Re: Turkey Point Units 3 and 4  
Docket Nos. 50-250 and 50-251  
License Amendment Request 196  
Alternative Source Term and Conforming Amendment

**LICENSE AMENDMENT REQUEST  
LAR 196**

**ALTERNATIVE SOURCE TERM  
AND CONFORMING AMENDMENT**

FIGURE 3.4.-1

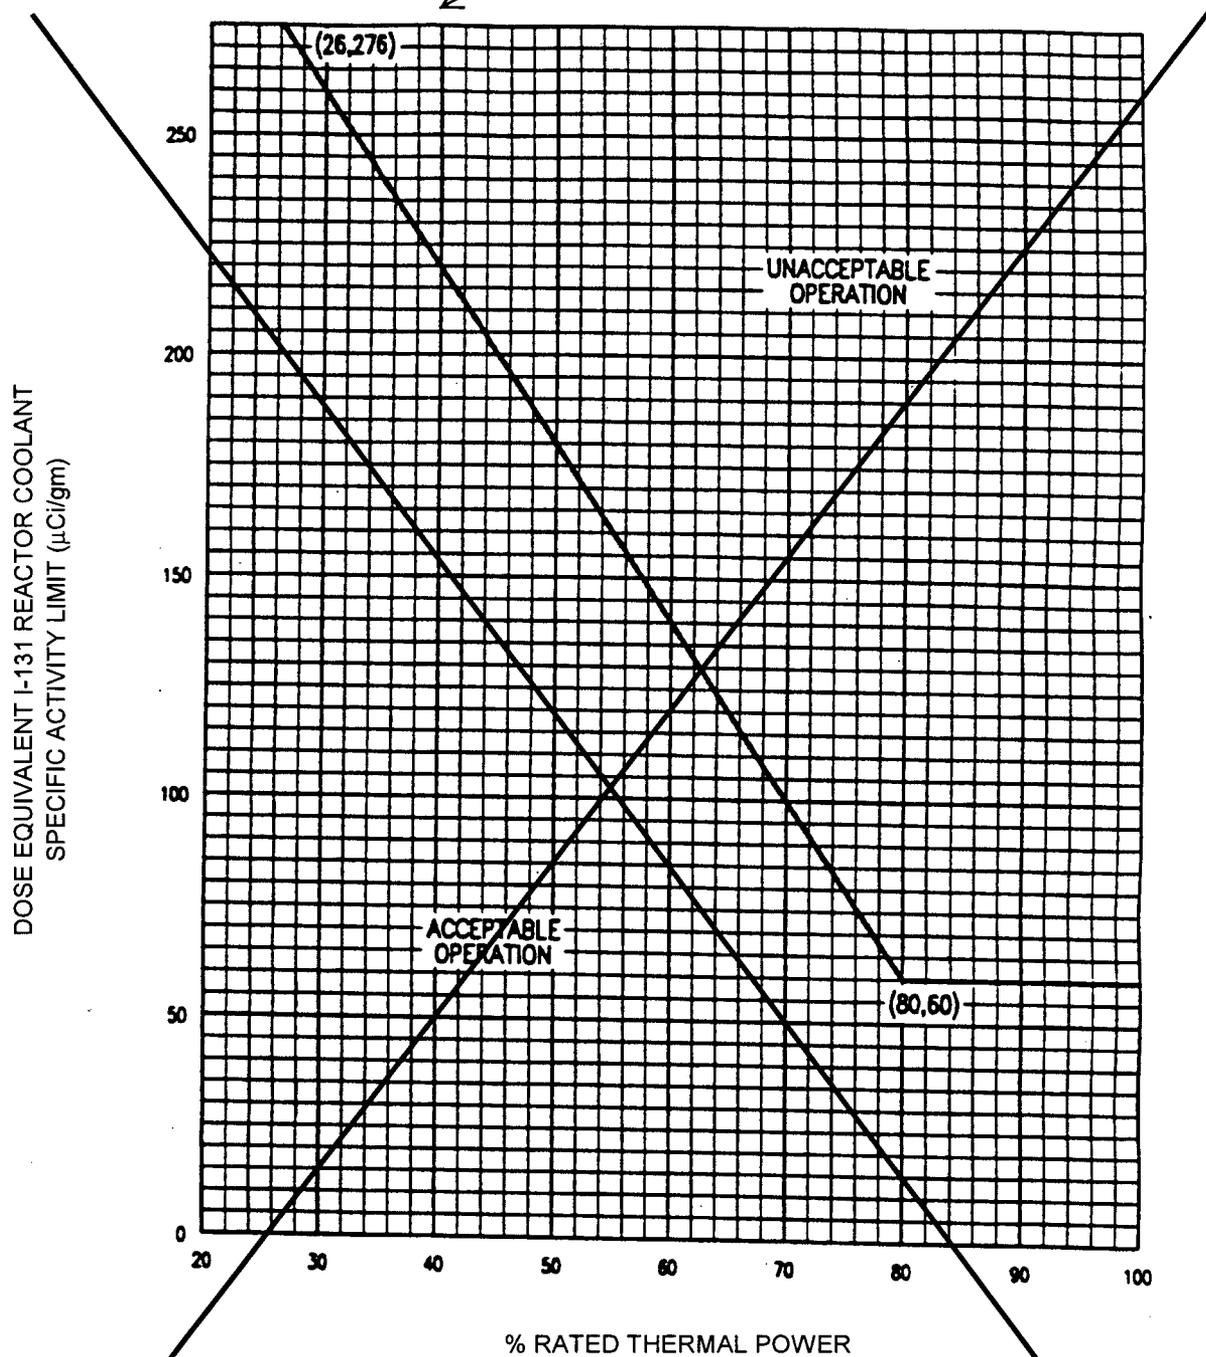
- FIGURE 3.4-1, DOSE EQUIVALENT I-131 REACTOR COOLANT SPECIFIC ACTIVITY LIMIT VERSUS PERCENT OF RATED THERMAL POWER WITH THE REACTOR COOLANT SPECIFIC ACTIVITY > 1 $\mu$ Ci/gram DOSE EQUIVALENT I-131 - This figure is deleted and replaced with “This page is intentionally left blank.”

Figure 3.4.-1, DEI-131 Reactor Coolant Specific Activity Limit vs. Rated Thermal Power with the Reactor Coolant Specific Activity > 1 $\mu$ ci/gram DEI-131, is deleted. The new limit is 60 microcuries per gram DEI-131 at all power levels. Action a. has been changed to delete the reference to Figure 3.4.-1 and to state greater than 60 microcuries per gram DEI-131. The change from a graph that changes with power level to a specific value is consistent with dose consequence events that are analyzed at full-power and assume a pre-accident spike of 60 microcuries per gram DEI-131. The full power transients that allow a DEI-131 spike are not changed.

New Actions a. through e. are incorporated to implement the new LCOs for DEI-131 and DOSE EQUIVALENT XE-133 and to replace Figure 3.4-1 with a specific value for DEI-131 of 60 microcuries per gram. Actions a. through c. provide the requirements for DEI-131. Actions d. and e., provide the requirements for DOSE EQUIVALENT XE-133. The required actions and completion times are consistent with the required actions and completion times in the current TS. However, Actions c. and e. have been revised to include a requirement to be in COLD SHUTDOWN within the next 30 hours. This requirement will ensure the unit is placed in a Mode where the TS is not Applicable.

**Figure 1.8.1-1**

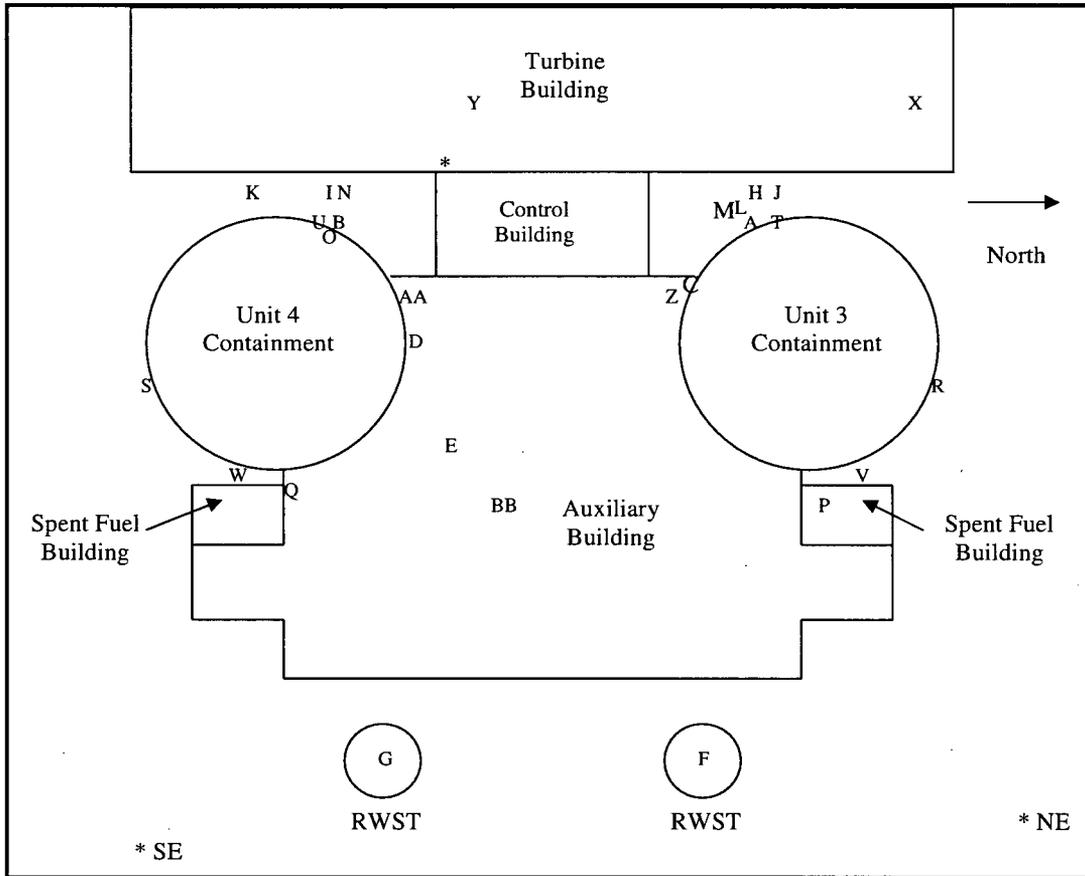
The Control Room Emergency Ventilation outside air intakes are being relocated from their current locations to new locations that fall within diverse wind sectors for post-accident contaminants. See Attachment 3, Figure 1.8.1-1. The relocated intakes will be designed to seismic criteria, protected from environmental effects, and will meet the requirements of 10 CFR 50 Appendix A, GDC 19 to satisfy the operability requirements for the control room emergency ventilation system. In the emergency/ recirculation mode of operation, the intakes will have balanced intake flow rates and capable of drawing outside makeup air from both analyzed intake locations. The intakes will be located near the ground level beyond the southeast and northeast corners of the auxiliary building. In accordance with RG 1.194 (Reference 12), the dispersion factors for the most conservative intake are selected and the dual intake dilution credit allows the X/Qs to the most limiting emergency intake to be reduced by a factor of two in the event analyses for all release points in separate wind sectors. Since the control room envelope remains pressurized while in the emergency/recirculation mode, unfiltered inleakage is modeled as makeup air which bypasses the filtration system. Modeling of the control room conservatively addresses these factors, as they apply to the various release locations for each analyzed event.

1. FPL will relocate the Control Room Ventilation System emergency air intakes prior to implementation of AST. The relocated intakes and associated ductwork will be designed to seismic criteria, protected from environmental effects, and will meet the requirements of 10 CFR 50 Appendix A, GDC 19. The new intakes will be located near the ground level of the southeast and northeast corners of the auxiliary building and will fall within diverse wind sectors for post-accident contaminants. FPL will perform post-modification testing in accordance with the plant design modification procedures to ensure the TS pressurization flow remains adequate to demonstrate the integrity of the relocated intakes.
